International Aero Engines SERVICE BULLETIN

ENGINE - FUEL AND CONTROL - TO PROVIDE A NEW A5SCN14/S ELECTRONIC ENGINE CONTROL (EEC)

V2500-ENG-73-0159

Family Tree - Electronic Engine Control (EEC)
Ref. Catalog Sequence No. 73-22-34. Fig. 01 Item 280 C
Figure 2 (Sheet 2)

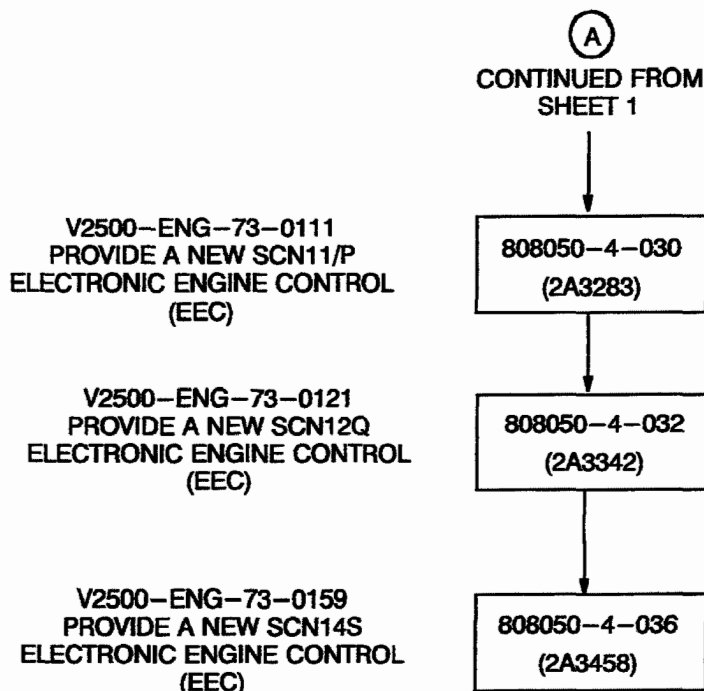
- (1) To provide a new Electronic Engine Control (EEC) with SCN14/S software logic.

(1D) The new part can be obtained through modification by the approved procedure in Reference (2). Purchase the new parts from or return the old parts for modification to one of the approved vendors listed in Paragraph 2. B. in the Accomplishment Instructions.
